REVISED RESPONSE TO REQUEST FOR ADDITIONAL INFORMATION

APR1400 Design Certification

RAI No.: 520-8693

Question No. 06.02.02-43

Figure 1

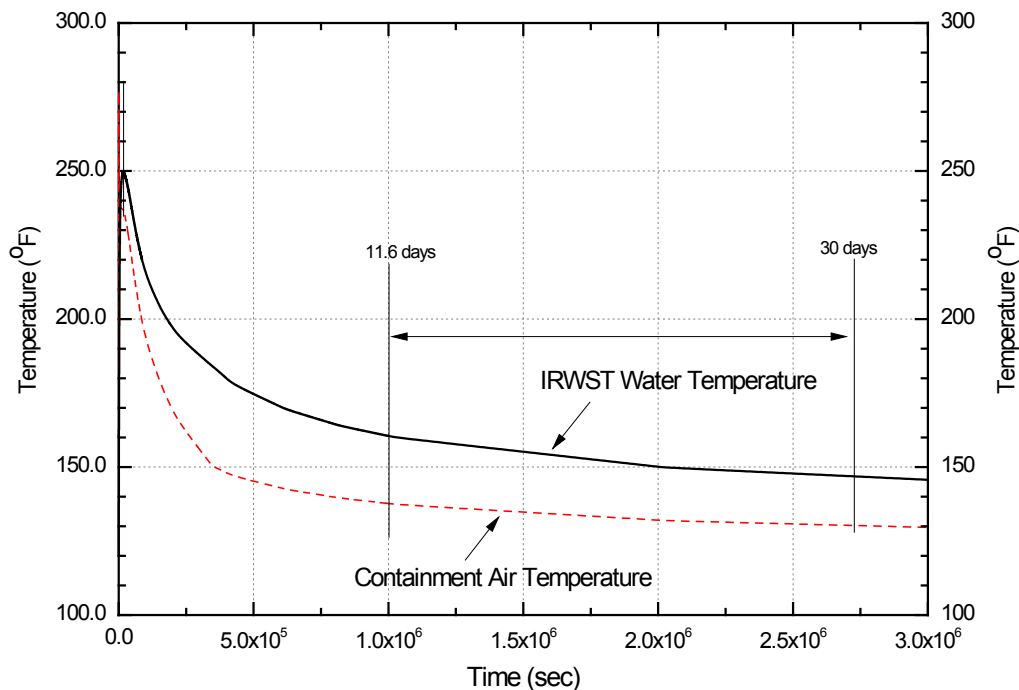
- a) description of how the sump and containment temperature profiles in FSAR Figure 6.2.1-4 were extended from 10^6 seconds to 30 days,
- b) a description of how the extension of the temperature profiles was documented, and
- c) the 30-day sump and containment temperature profiles used in the chemical precipitate calculations.

The containment and sump temperature profiles, which were produced from the limiting LOCA that yields the maximum containment pressure, had been used for calculating the chemical effect until the DCD Rev. 1. However, The LOCA containment analysis that yields the highest sump temperature has some differences in the containment initial conditions from that applied to the containment model described in DCD Section 6.2.1 that maximizes the containment pressure. Thus, the containment responses to a LOCA were recalculated with the initial conditions that maximizes the sump temperature and its results has been finally chosen for the chemical effect analysis.

The description of the containment model that yields the highest sump temperature is presented in the Appendix B, Section B.4 of Technical report, APR1400-Z-A-NR-14007-P, "Mass and Energy Release Methodologies for LOCA and MSLB", Rev. 2. From the comparison of all LOCA analyses, the scenario that yields highest sump temperature is estimated to the case "Double-ended discharge leg slot break with Max. SI flow".

Figure 1 below illustrates the temperature profiles of the containment and sump extended up to 30 days of the accident.
